Motex Fashion

802/1, Jajor, National University, Gazipur-1704

5 September 2021

Observations

Report: Soil bearing capacity 1.80 tsf at 8 feet (2.4m) depth

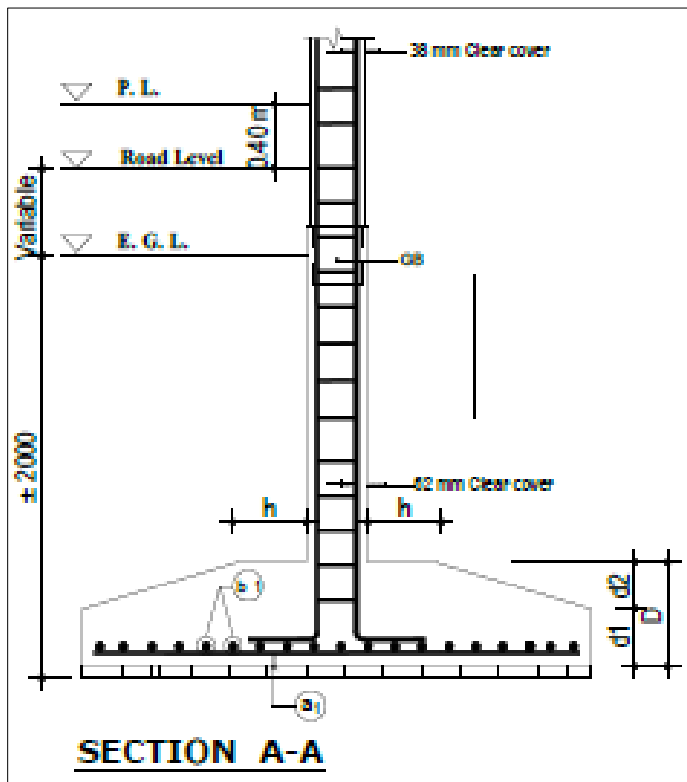
Footing depth considered in design report 10 feet (3m).

Footing depth about 2m (6.56 feet)

As per drawing, isolated footing is provided in 6.56 feet depth. Geotechnical report recommend bearing capacity for 8 feet depth. In the design report, SPT calculated for 10 feet depth and calculated soil bearing stress accordingly. Revise the footing bearing stress calculation as per actual foundation depth.

Loading in storage area of 3rd floor.

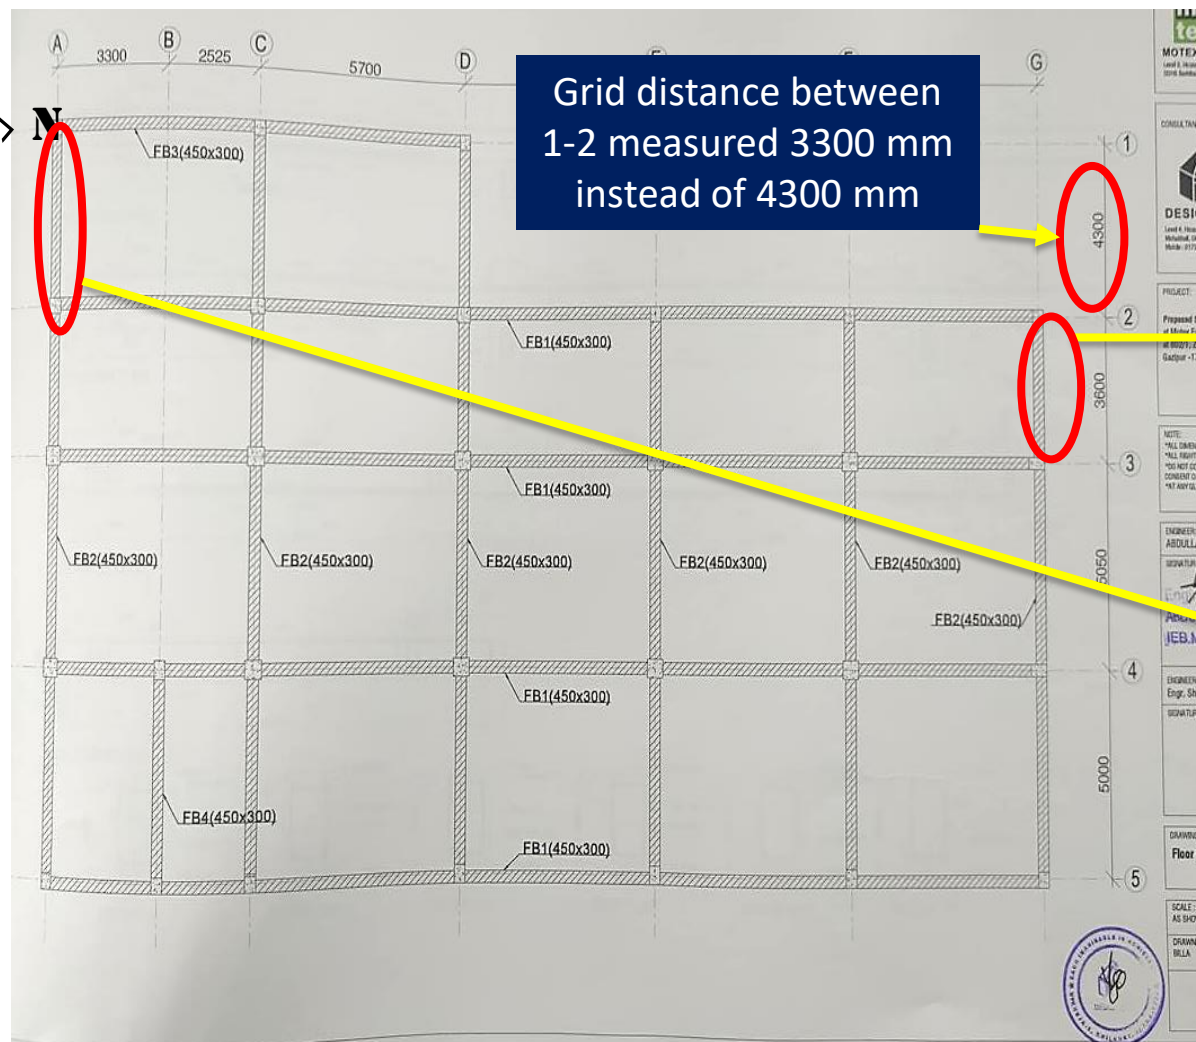
Uncontrolled loading on 3rd floor.

4 to 5 kPa loading was found in storage area (3rd floor). Also, load management program was not observed. Produce and actively manage a loading plan for all floor plates considering the foundation and column capacity.

Floor Roof Beam Layout Plan(marked beams are missing)

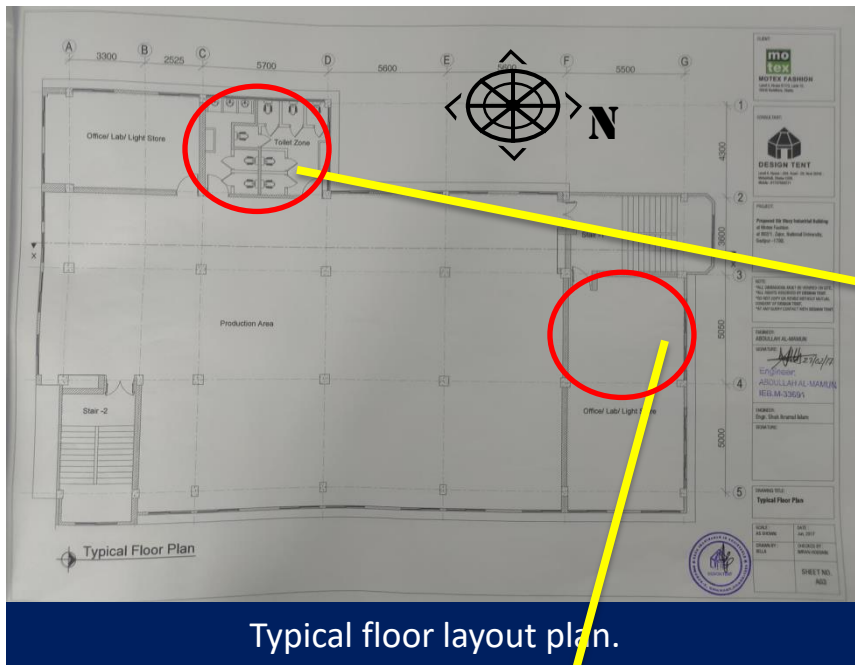
Some stair beams were missing on-site but shown in the provided drawings. Grid distance between 1 and 2 was measured 3300mm instead of 4300mm. Update as-built drawings as per actual as-built condition.

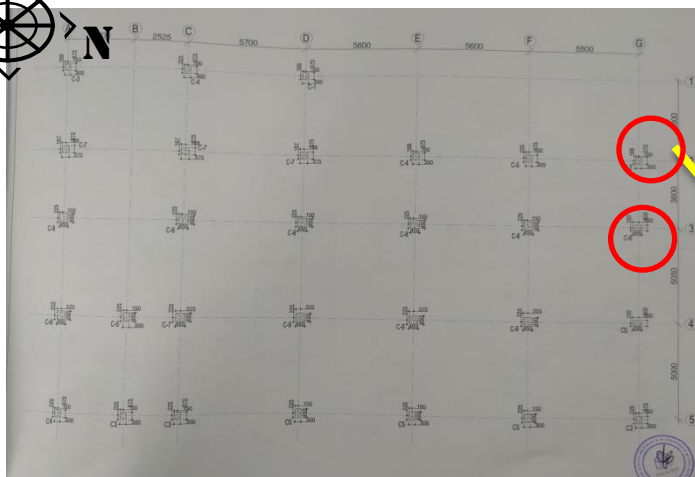
Toilet layout did not match with as-built drawings. Toilet build up was not shown in drawings.

Column schedule

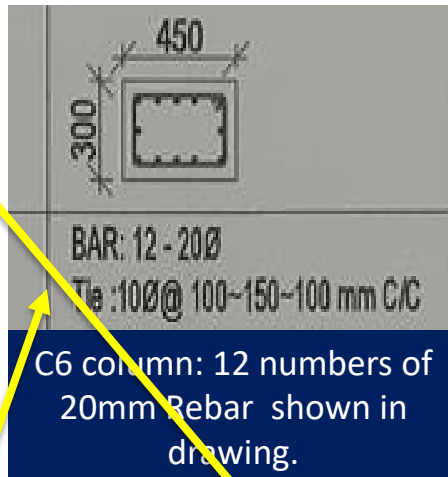
C6 column: 12 numbers of 20mm Rebar shown in drawing.

C6 column: Rebar diameter 16mm

C6 Column: 8 numbers of 20mm & 2 number 16mm of Rebar counted.

C2 type column rebar orientation did not match with drawing.

3x2000 liter plastic water tanks on the roof

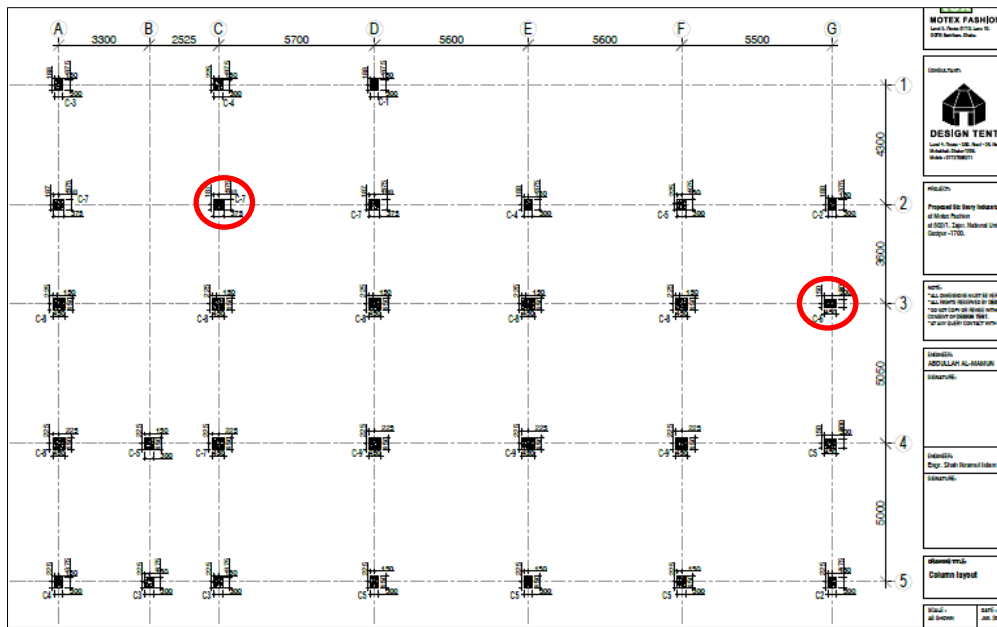
Undocumented plastic water tanks on the roof

Column & footing at grid C-2 and G-3

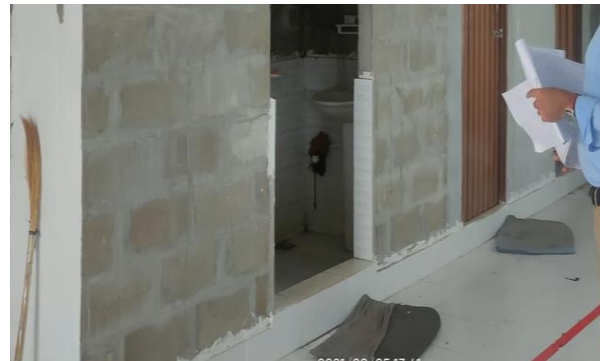
**Column and Footing to be over-stressed for
proposed 6 storey Building**

Vertical extension work of this building is going on. Cursory calculation indicates that for proposed 6 storied building the stress in column and footing will be exceeded normal design limit. The calculation is carried out based on minimum concrete strength and proposed floor live load of design report.

Toilet zone with raise & ceiling

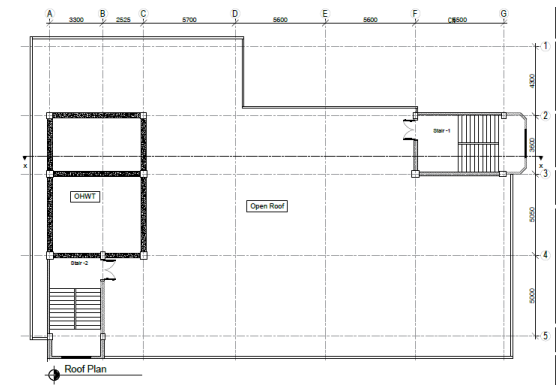
Extension work on 4th floor
